**Peckfield Level Crossing
Closure, Pit Lane, Micklefield
Non Motorised User Route
Safety Assessment**

ProjectWise Reference No:
151666-TRA-E3-HUL4-REP-W-HW-800343
Version: C01
Document Date: 24/10/2023
Suitability Status: Fit for Construction

APPENDIX B – PROBLEM LOCATION PLAN

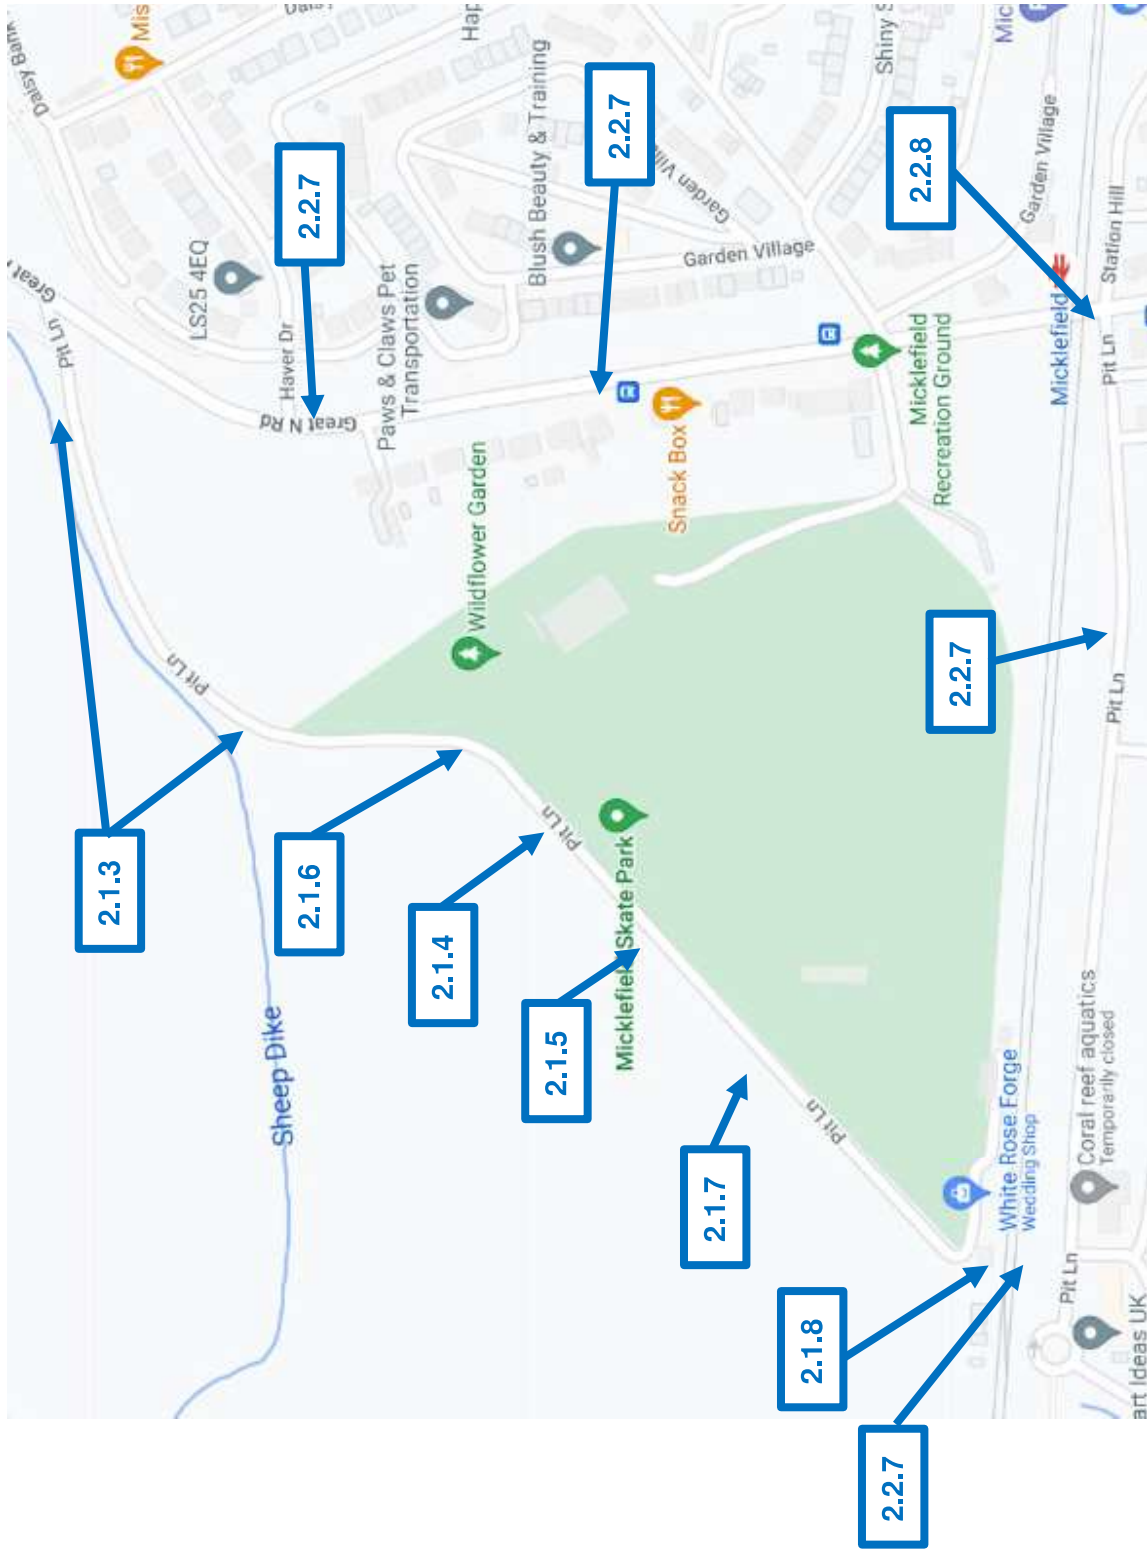
4.2.2 Footway maintenance should be undertaken to clear the overgrowth in the locations on Great North Road and Pit Lane as shown on the plan at Appendix B.

4.2.3 Tactile paving should be provided at the dropped crossing point across the junction mouth of Pit Lane and the 'Give Way' sign relocated to avoid causing an obstruction to the crossing.

4.3.2 Noted. This report will be forwarded to LCC for information.

4.3.3 Noted. Tactile paving at the junction of Pit Lane and Great North Road is believed to be covered by the s278 agreement between LCC and the housing developer.
